project #
PW0032

Hillside Court Headwall

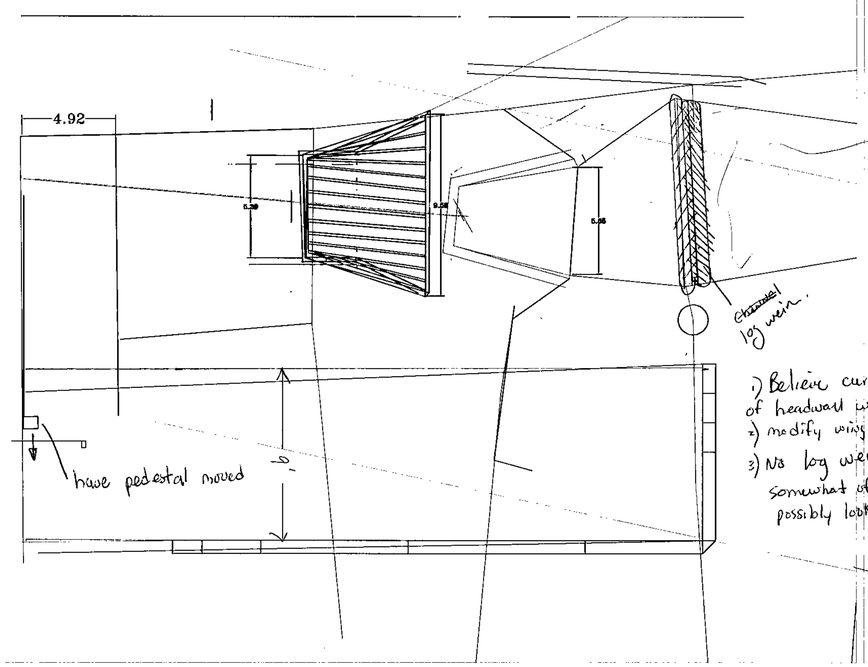
1) Believe current location of headwall will work
2) modify wing walls (widen out)
3) No log weir, there is somewhat of a natural one in place possibly look at putting something up the creek
